**Important Product Bulletin**  
**Eaton 9PXM, CTO Number 9PXM08xxxxx and 9PXM12xxxxx**  
**Eaton 9PXM Product Accessories, 730-06185 and 730-06196**  
**Customer Notification**

Eaton has identified a potential nonconformance with the following 9PXM and 9PXM Accessory part numbers (the “Products”).

**Figure 1: Part Number on the UPS packaging**

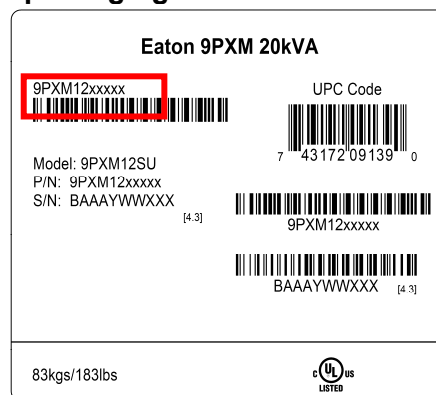
1. Identify potentially affected UPS units by looking for Part Number 9PXM12xxxxx or 9PXM08xxxxx on the carton, as shown above in Figure 1, or the label on the UPS, as shown above in Figure 2.
2. If the unit is already installed use the display to go to the Menu/Identification/CSB Firmware as shown in Figure 7. If UPS CSB firmware is another revision besides **2.02.0001** then update the UPS CSB firmware.

**Figure 8: Display appearance when checking the UPM/Supercharger Firmware**

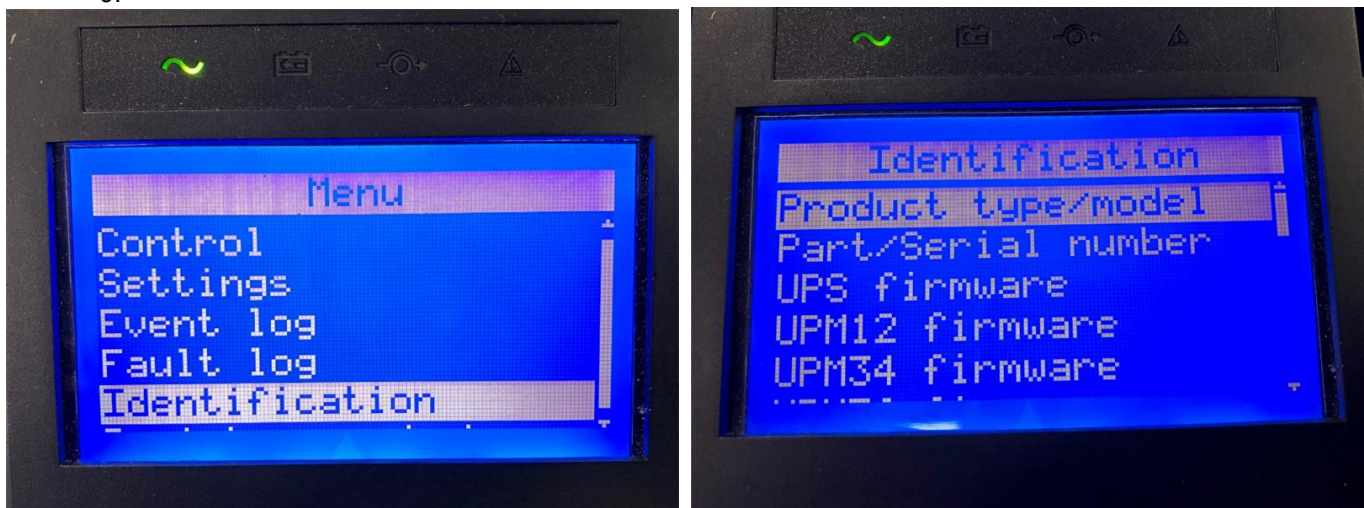
3. Identify potentially affected Universal Power Modules (UPM) by looking for Part Number 730-06185 on the carton as shown above in Figure 3, or on the UPM as shown above in Figure 4.
4. Identify potentially affected Superchargers by looking for Part Number 730-06196 on the carton as shown above in Figure 3, or on the Supercharger as shown above in Figure 4.
5. If the UPM/Supercharger is already installed use the display to go to the Menu/Identification as shown in Figure 8. Select the appropriate device. If UPM/Supercharger is another revision besides **2.08.0001** then update both the UPM and Supercharger firmware. The display with firmware **2.08.0001** is shown in Figure 9.
